Re: Addendum Work Plan for Soil & Water Investigation  
Former BP Service Station #11266  
1541 Park Street  
Alameda, California  
ACEH Case # RO0000318

Project No. 06-88-658

Re: Addendum Work Plan for Soil & Water Investigation, Former BP Station No.11266,  
1541 Park Street, Alameda, California; Case No. RO0000318

Proposed Boring B-1

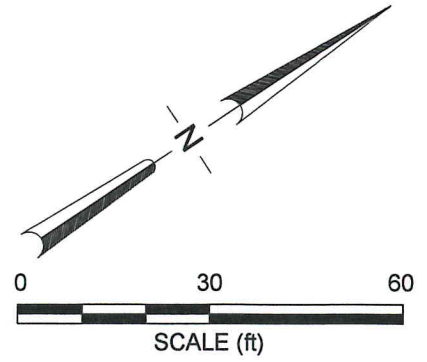
In responding to the ACEH letter dated 8 April 2009, BAI must note that the drawing originally depicting the location of sample C-1 was not drawn to scale (Kaprealian Engineering, Inc., 10/12/1987). After performing Site reconnaissance and background research, BAI noted that the concrete slab over the top of the existing USTs extends almost to the northwestern ends of the two dispenser islands and approximately to the vertical edge of the overhead canopy. The pipeline runs, also under concrete, are believed to be along the northern side of each dispenser island, leaving an area of asphalt between the two dispenser islands currently thought to be absent of underground utilities. Therefore, boring B-1 is proposed to be moved to an area between the dispenser islands, almost adjacent to the southeastern edge of the concrete slab over the existing USTs, and close to the approximate location of historic tank excavation sidewall sample C-1, as

shown in the revised Drawing 1 and the attached photo-markup. In accordance with BP safety policy, this proposed boring location will have to be advanced by hand-auger due to its proximity to civil structures. Furthermore, it has been decided that proposed boring B-2 in the vicinity of the oil storage tank will also be advanced by hand-auger. However, if pea gravel is encountered during advancement of the borings, the boring locations will be immediately abandoned, as required by BP safety policy. The proposed sample collection activities shall remain as stated within the *Work Plan*.
